Intel[®] Pentium[®] III Processor Specification Update

Release Date: December 2002

Document Number: 244453-046

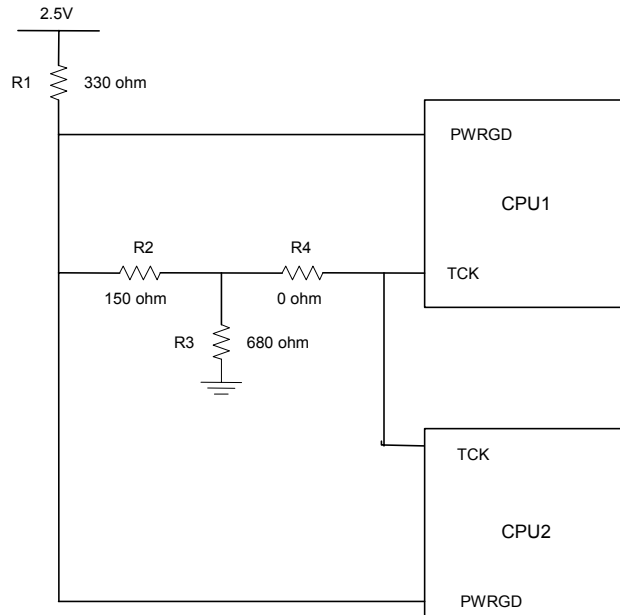
Problem: The internal control register bit responsible for operation of the Thermtrip circuit functionality may power up in a non-initialized state. As a result, THERMTRIP# may be incorrectly asserted during de-assertion of RESET# at nominal operating temperatures. When THERMTRIP# is asserted as a result of this erratum, the processor may shut down internally and stop execution but in few cases continue to execute.

Implication: This issue can lead to intermittent system power-on boot failures. The occurrence and repeatability of failures is system dependent, however all systems and processors are susceptible to failure. In addition, the processor may fail to stop execution during the event of a valid THERMTRIP# assertion resulting in the potential for permanent processor damage.

Workaround: To prevent the risk of power-on boot failures or catastrophic thermal failures, a platform workaround is required. The system must provide a rising edge on the TCK signal during the power-on sequence that meets all of the following requirements:

- Rising edge occurs after Vcc_core is valid and stable
- Rising edge occurs before or at the de-assertion of RESET#
- Rising edge occurs after all Vref input signals are at valid voltage levels
- TCK input meets the Vih min and max spec as mentioned in EMTS
